FIELD SERVICE BULLETIN

FSB Number: LVCCFSB2005-311
Author: Max Dekirmandjian
Date: October 11, 2005
Total No. of Pages: 4
Subject: E398 GSM 256 MB TransFlash Card No Detect
Model Affected: E398 GSM
Level of Repair: 3

Photo #4

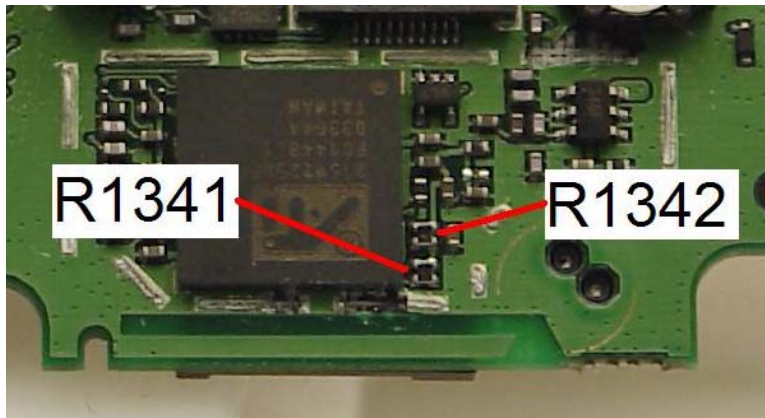
Service is aware of an issue with the E398 GSM phone when used with a TransFlash card. The unit is not able to recognize a 256MB memory card. No problems were reported with the 64 or 128MB card. The root cause is due to two resistors on the PCB, R1341 & R1342 having the orientation misplaced by 90 deg. These PCB's were manufactured by supplier Venture in April 2005. 37K units are affected.

10) Inspect R1341 & R1342 for proper orientation as shown in Photo #4. If in doubt, compare the orientation to a known good board. Reposition if necessary;

The PCB manufacturer corrected their component placement process starting May 2005. In addition, Mot AMK has incorporated a 256MB Transflash card test at their CIT station.
